UNITED STATES PATENT AND TRADEMARK OFFICE

APPLICATION NO.	FILING DATE	FIRST NAMED INVENTOR	ATTORNEY DOCKET NO.	CONFIRMATION NO.
10/501,423	07/13/2004	Johannes Jacobus Franciscus Geijtenbeek	NL 020024	9929

Office Action Summary

DETAILED ACTION

FIG. 1

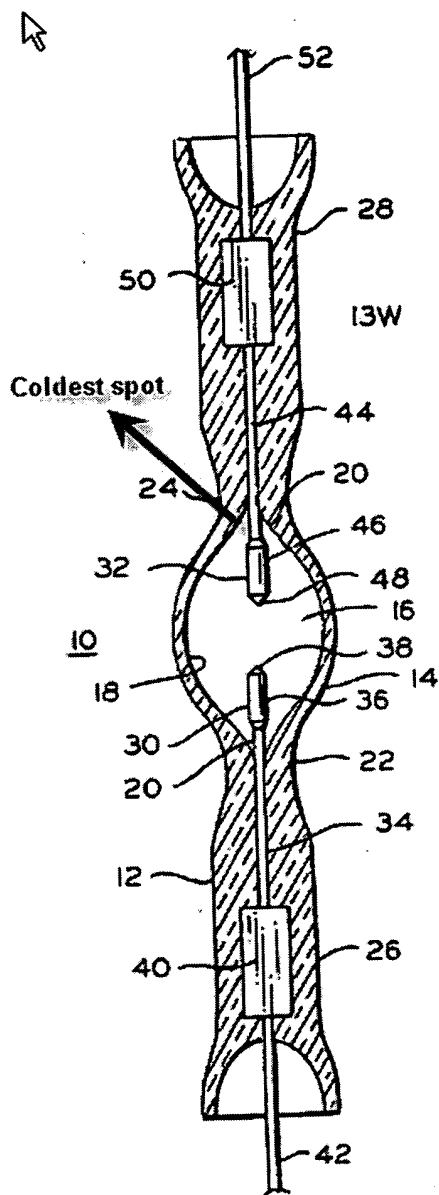
Graham discloses in figure 1, Metal halide lamp, most specifically a metal halide lamp with an aspect ratio greater than 3, comprising a discharge chamber (16) having walls sealingly enclosing the discharge chamber; two electrodes (30,32) arranged in the discharge chamber opposite each other, for burning an arc therebetween; the discharge chamber containing a saturated system comprising an excess amount of salt

(col.5, lines 16 +), such as for instance metal halides, such that during operation of the lamp, a salt pool of melted salt will be present inside the discharge chamber; the lamp being designed such that, when the lamp is operative in a vertical orientation (Figures 1-3), the location of the salt pool is close to the top of the discharge chamber.

Accordingly, Applicant submits that "However, he does not show the salt pool 98 near the top of the discharge chamber, but rather shows the salt pool near the bottom of the chamber (Fig. 3)."

The Examiner respectfully disagreed with the Applicant's argument above, since Graham discloses the salt pool in figure 3, is close to the top of the discharge chamber ("close to" is a relative term)
